ADDENDUM NO. 3

Perry Township Schools:
Southport High School Addition & Renovation Phase 1 (Activity Center Addition &
Wrestling/Center Plant Renovation)
971 E. Banta Road
Indianapolis, IN 46227

ADDENDUM NO. THREE

DATE OF ADDENDUM: February 12, 2026

ELECTRICAL ONE-LINE DIAGRAMS

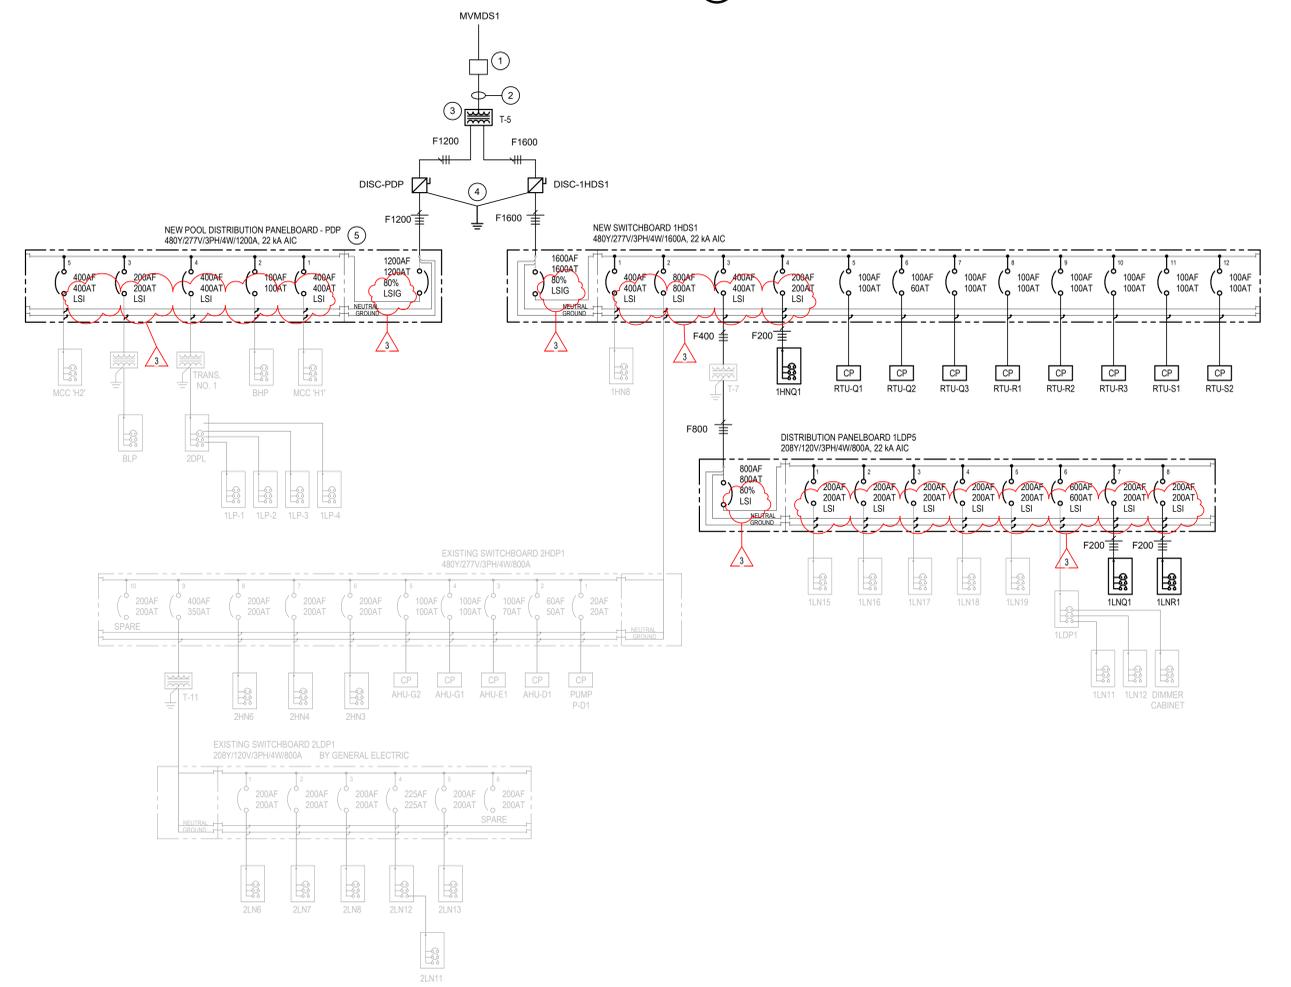
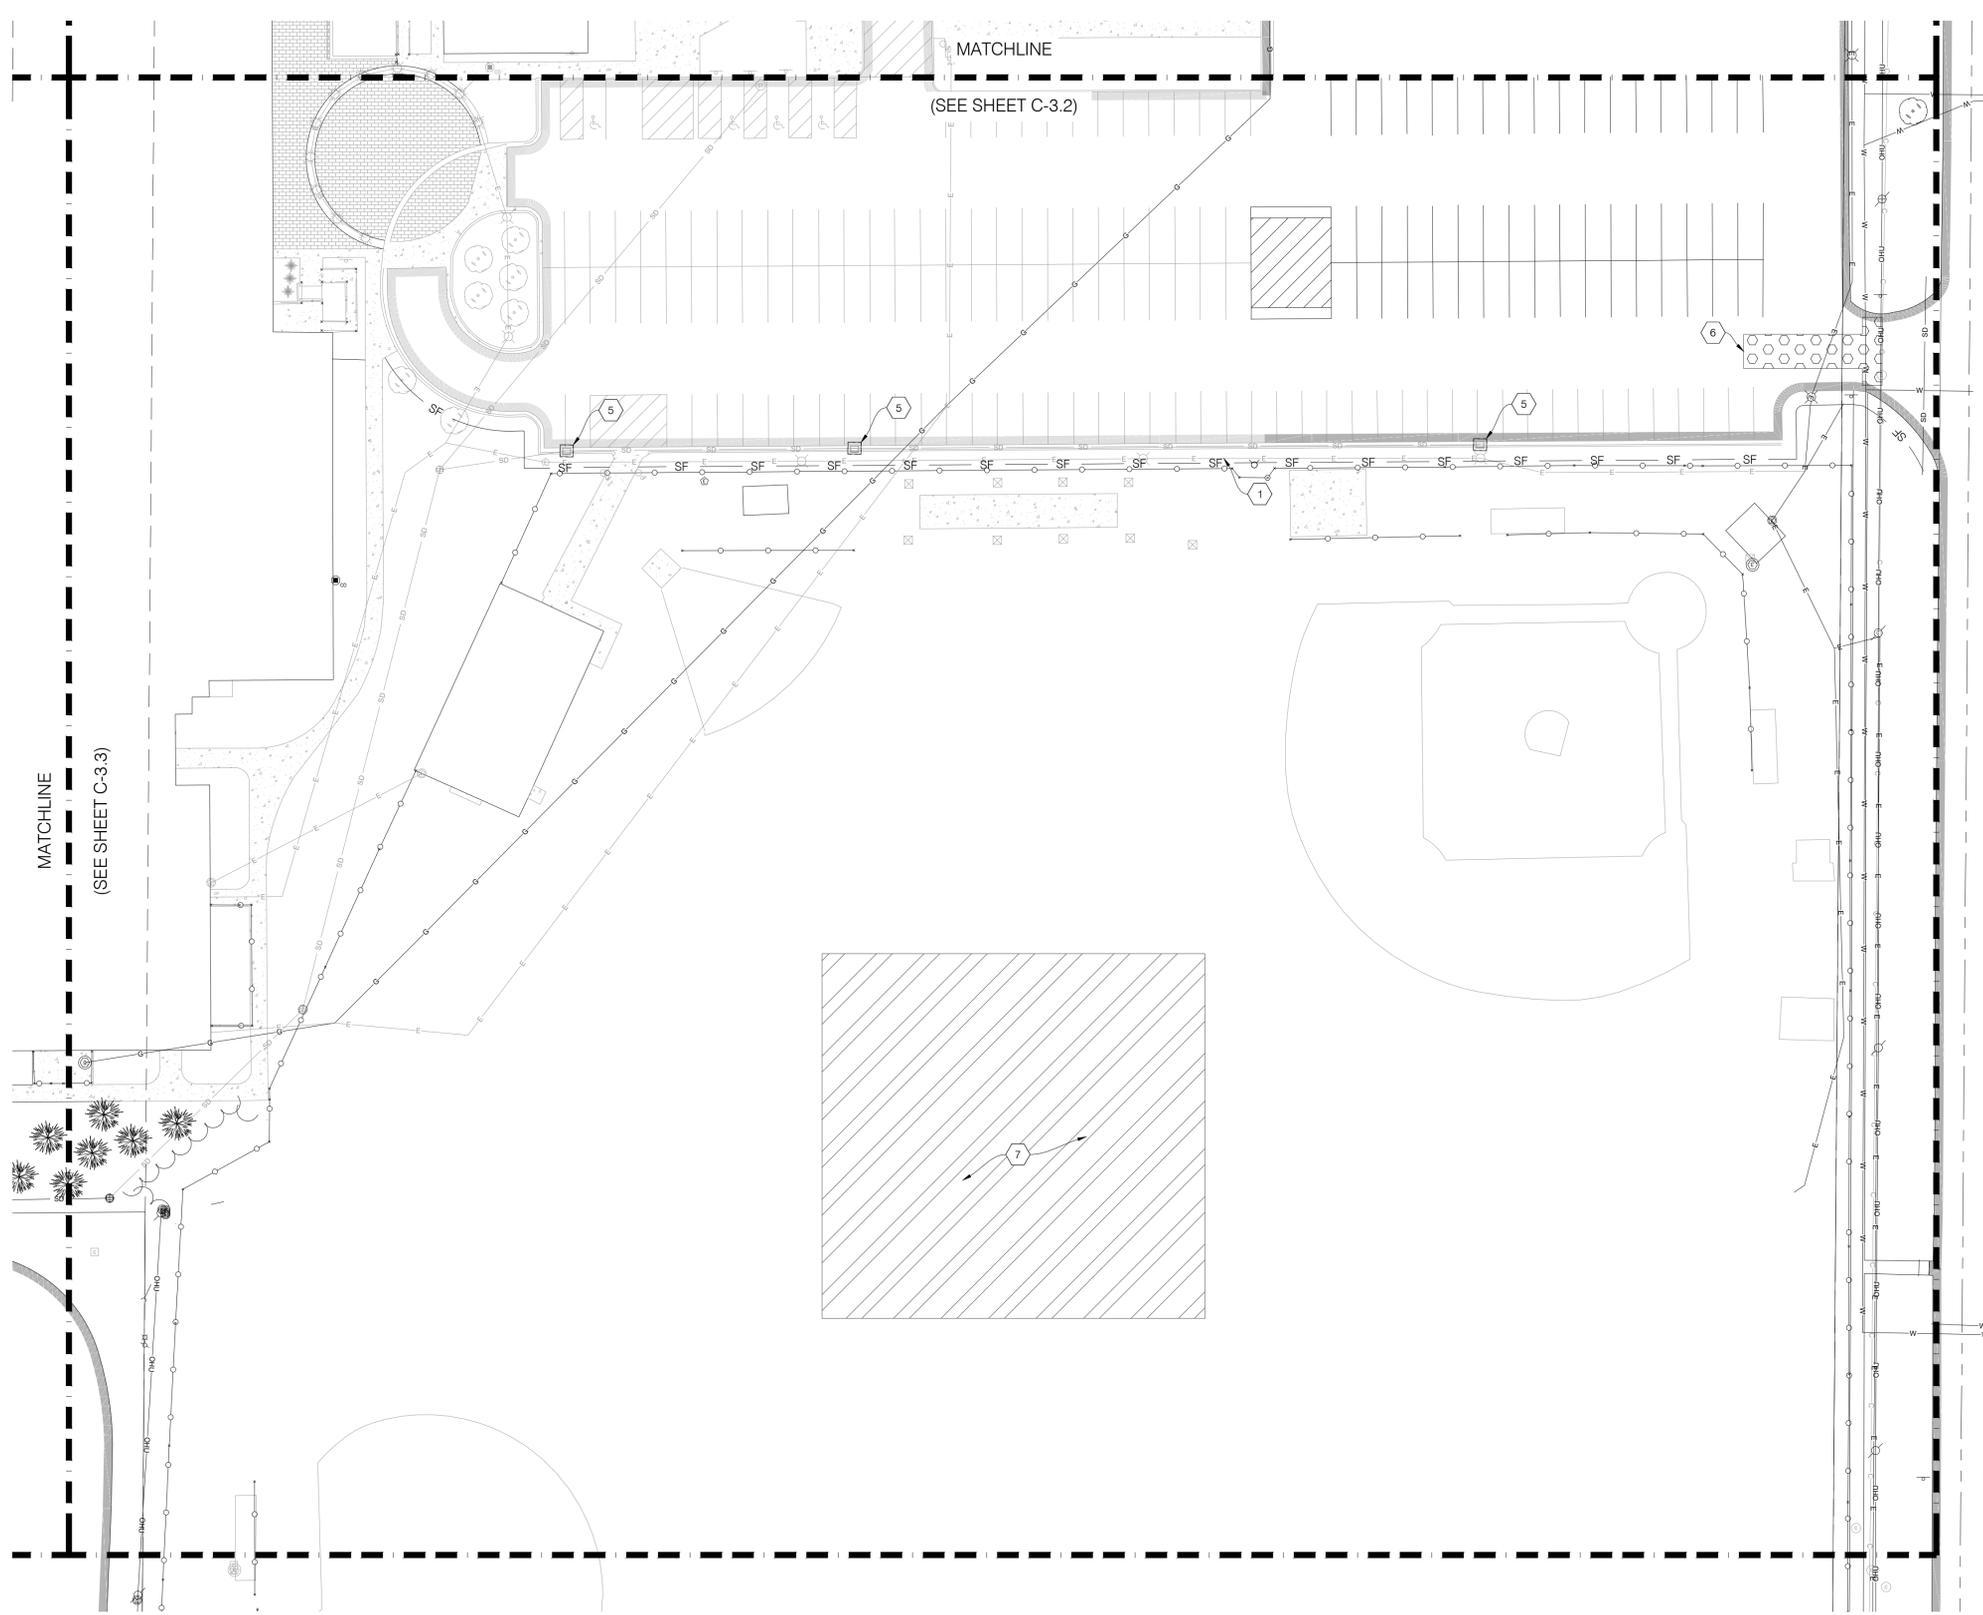
Change: Added LSI and LSIG to specific circuit breakers in switchboards and distribution panels.

DEMO EROSION CONTROL PLAN

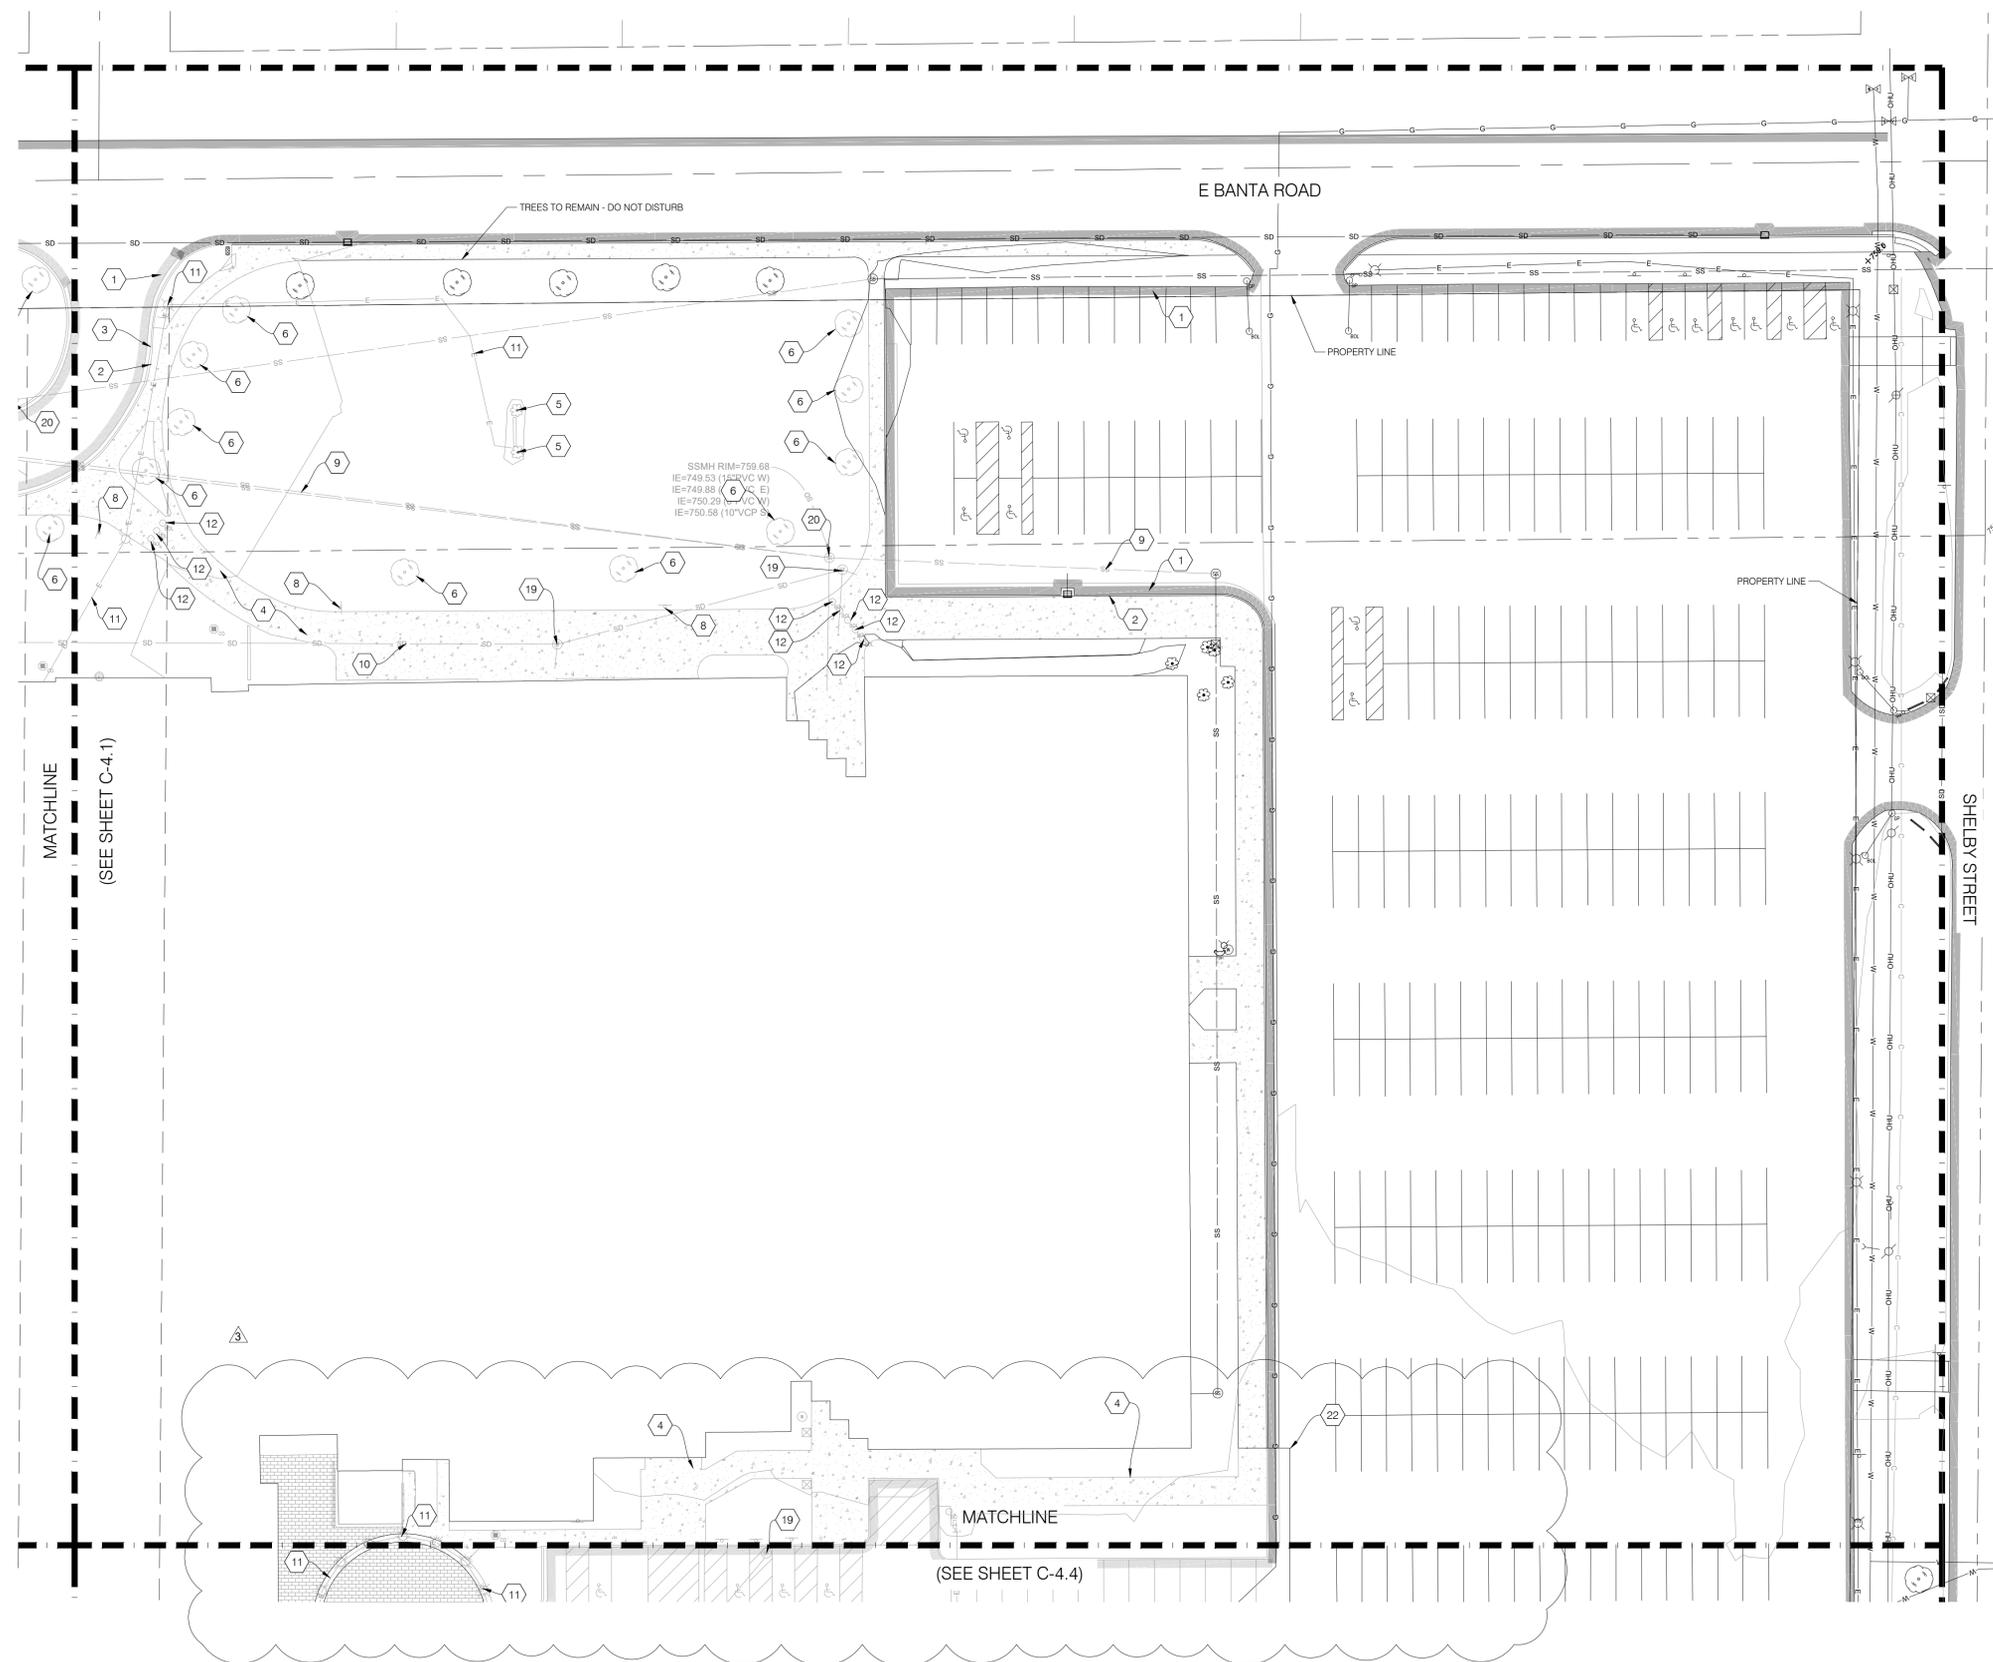
Change: Modify Demo Erosion Control Plan Legend
 - Modify plan legend note 6.

C-4.2

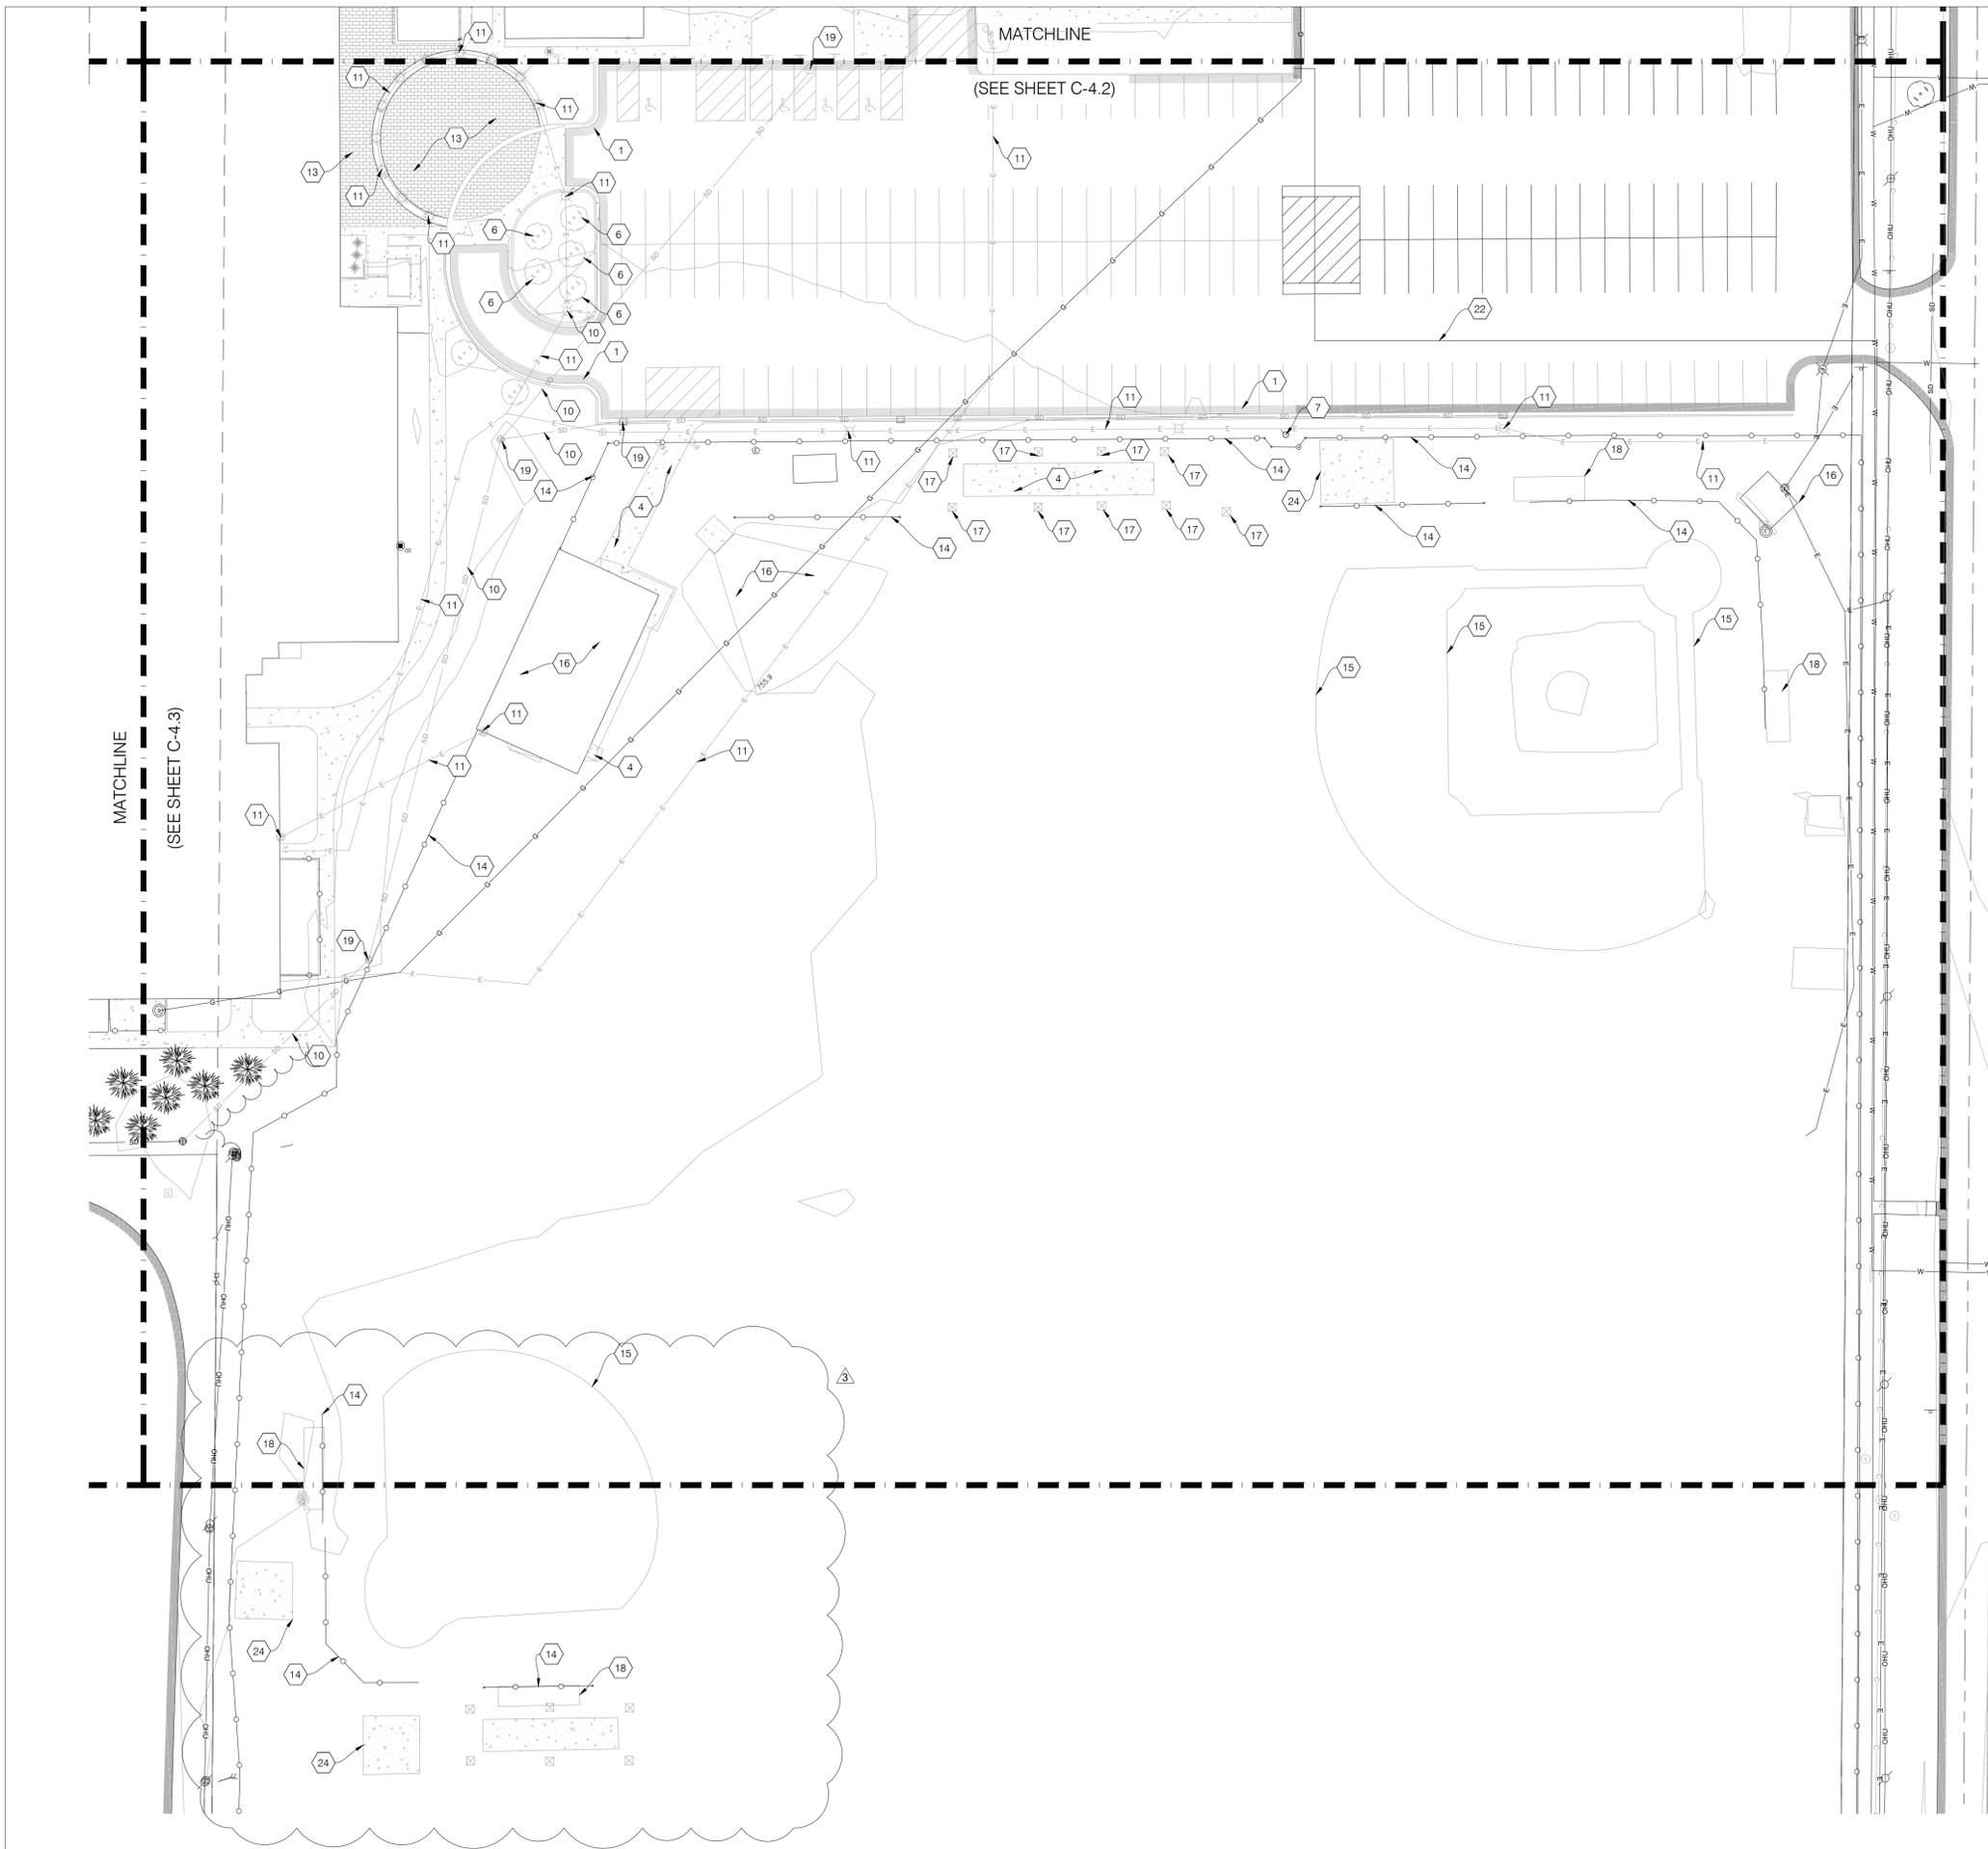
Change: Notation for extents of demolition.
 - Add demo notes to identify extent of work.
